Service Bulletin No. 434

MODEL	J4500 Series	TYPE	Field Change Program	SECTION/GROUP	7-Electrical	DATE	June 9, 2016
SUBJECT	DD13 ENGINE REGENERATION AT LOW AMBIENT TEMPERATURE						
CONDITIONS

Figure 1.

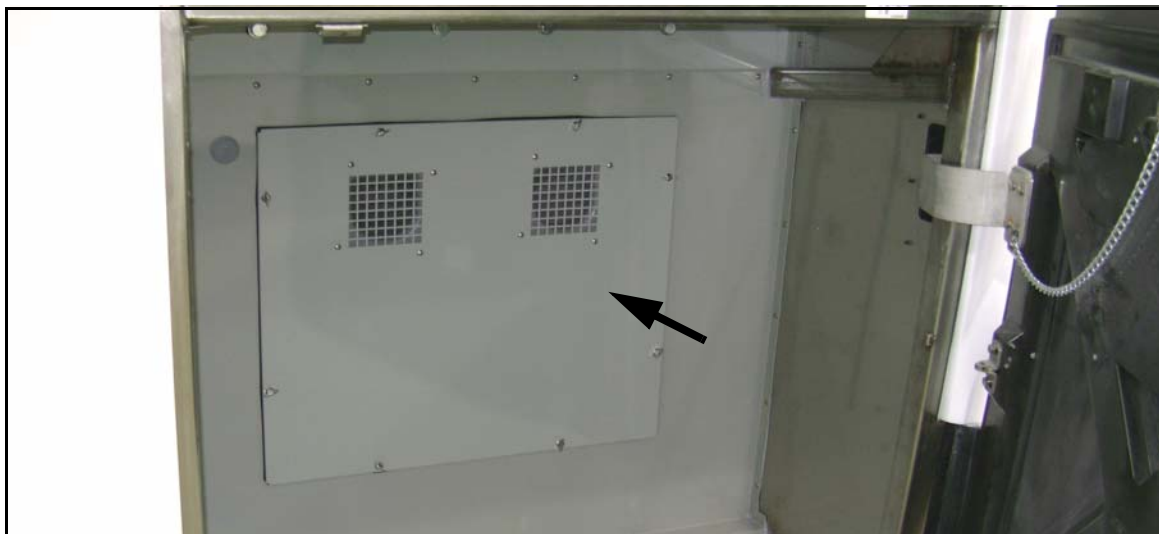
4. Locate the closing panel on the rear wall of the wheelchair lift compartment. Release the eight (8) fasteners on the closing panel and place aside to be re-installed at a later step in this procedure. Refer to Figure 1.

Figure 2.

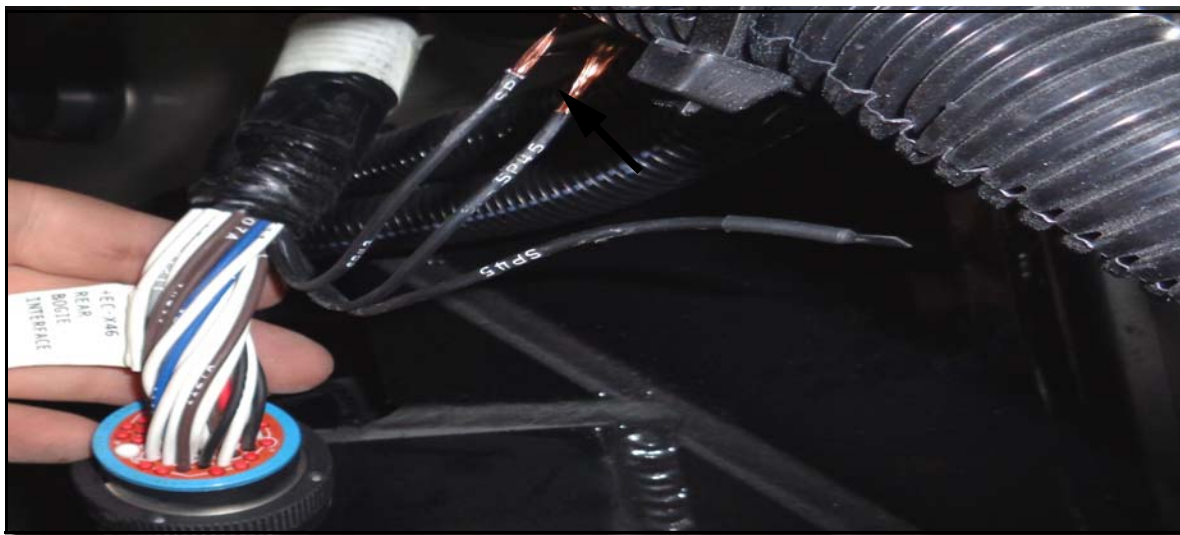
5. Locate Plug +EC-X46 on bulk head. Locate spare wires SP3 and SP5 in the 07-12-3601 harness.
6. Using wire cutters, cut the harness, p/n 07-12-5955, four (4) feet back from the connector +EC-BYPASS (plug) end.
7. Using wire strippers, strip off 0.250 inch from the wires on the four (4) foot section of cut harness Using solder, splice ring and heat shrink, splice on red wire CKT1904 from harness, p/n 07-12-5955, to SP3 in 07-12-3601 harness. Splice the black wire CKT1901A from harness, p/n 07-12-5955, to SP5. Apply electrical tape and loom to the harness.

Figure 3.

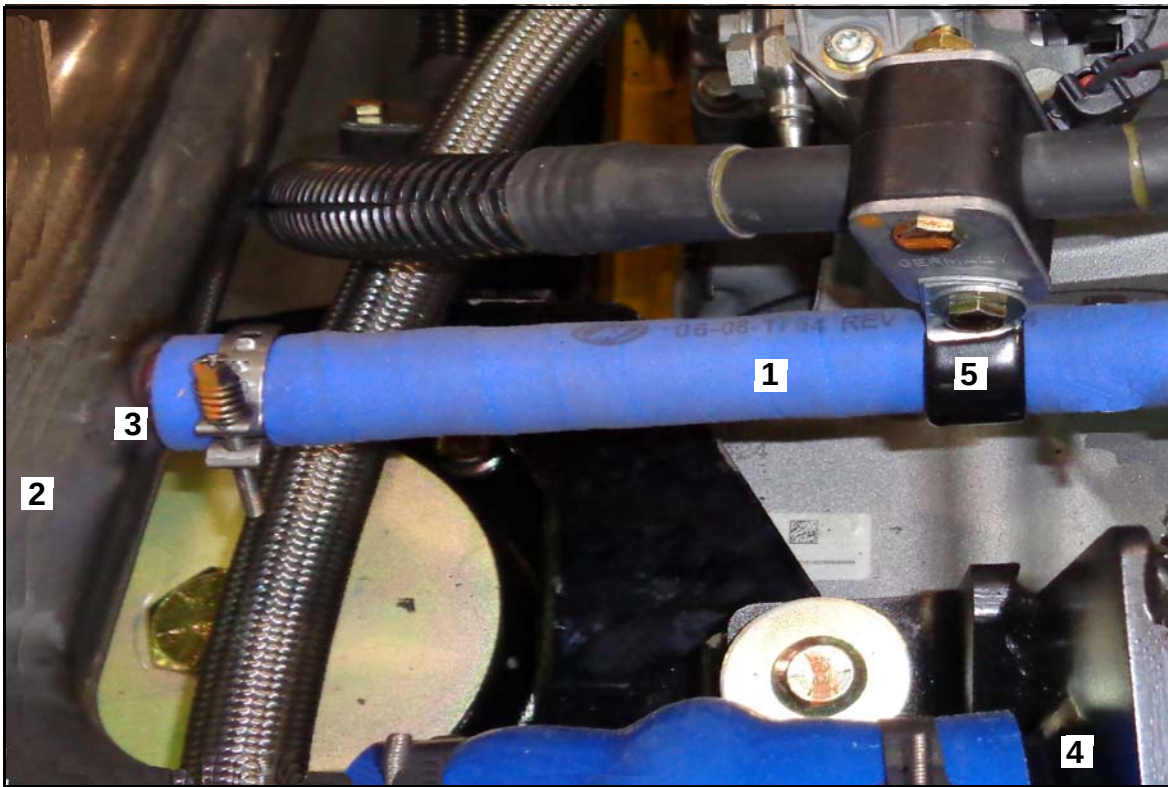
8. Locate the coolant hose (refer to Item 1 / Figure 3).
9. Locate the coolant hose line clamp (refer to Item 5 / Figure 3). Remove and retain the line clamp and mounting hardware.
10. Using a marker and tape measure, mark a line at the 9.50 and 14.00 inch point using Item 3 / Figure 3 as the starting point.

11. Using hose cutters and wire cutters, cut the hose jacket and wire framing at the lines made in Step 10. Discard the cut piece.

12. Orient the coolant bypass valve, p/n 16-16-1616, ensuring that the casting stamped "IN" port is facing towards the curbside of the coach. Slide one (1) stepless spring clamp, p/n 19-4-230, over both ends of the cut hose end. Install the valve utilizing the cut hose ends as shown in Figure 4. Orient and tighten the stepless spring clamp over the valve ports. Torque clamps to 12-14 in.-lbs.
13. Re-install the coolant hose line clamp (refer to Item 5 / Figure 3).

Figure 5.

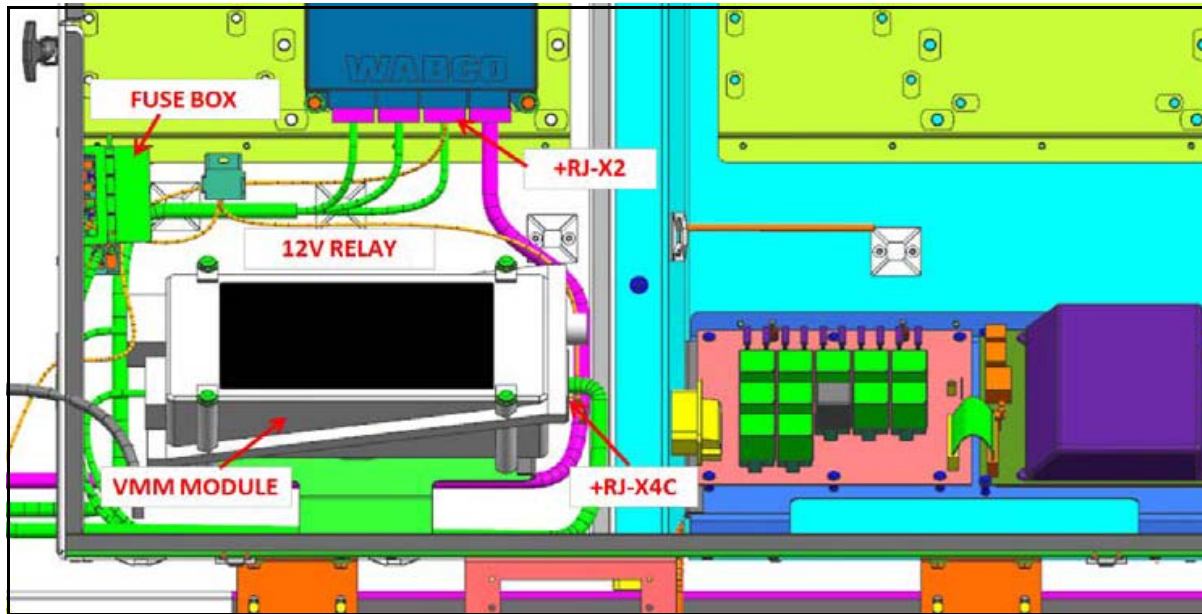
16. Locate the Plug +RJ-X2 on the Wabco ABS module. Locate spare wires SP3 and SP5 in the 07-12-3601 harness six (6) inches back from the plug.

17. Using wire strippers, strip 0.250 inch from the cut red wire CKT1904 and SP3. Using solder, splice ring and heat shrink, splice on red wire CKT1904 from harness, p/n 07-12-5955, to SP3.
18. In the rear junction box, using wire strippers, strip the cut black wire CKT1901A and SP5 0.250 inch. Using solder, splice ring and heat shrink, splice on black wire CKT1901A from harness, p/n 07-12-5955, to SP5.
19. Locate Plug +RJ-X4C on the VMM module. Locate Pin 25 on Plug +RJ-X4C.
20. Remove the plug from the cavity and populate Pin 25 with the pin end (CKT 1902 / white wire) of the harness 07-12-5955.

Figure 6.

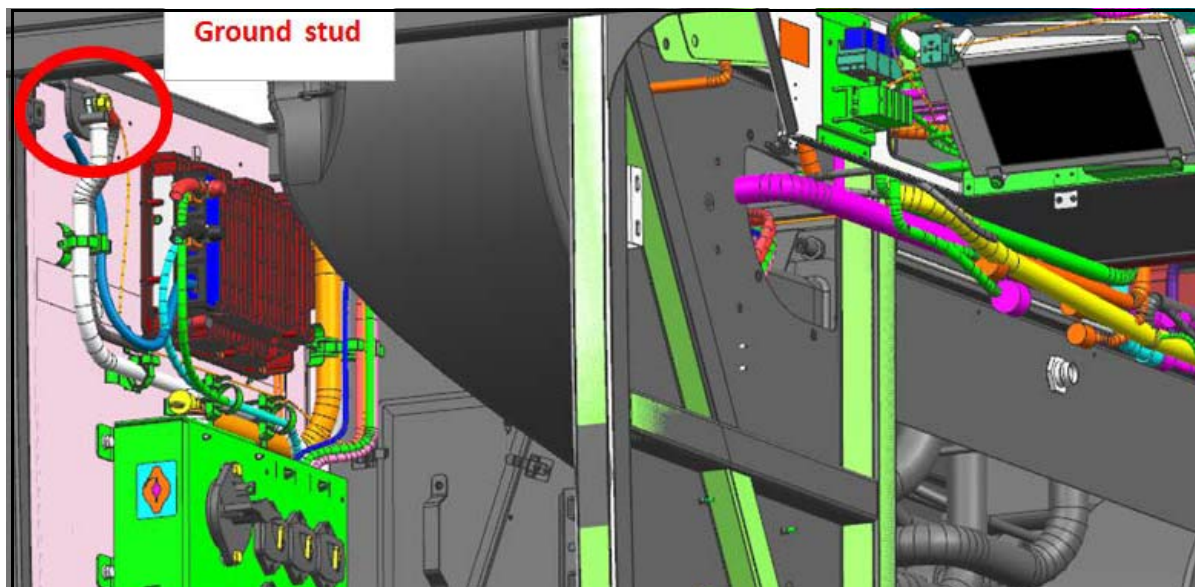
22. Route the ring terminal end of the remaining cut section of the harness, p/n 07-12-5955 from the rear junction box to the ground stud in the battery compartment (refer to Figure 6).
23. Using existing hardware, install the ring terminal. Torque to 3-5 ft-lbs. Apply Hi-Tack to the ground stud area.
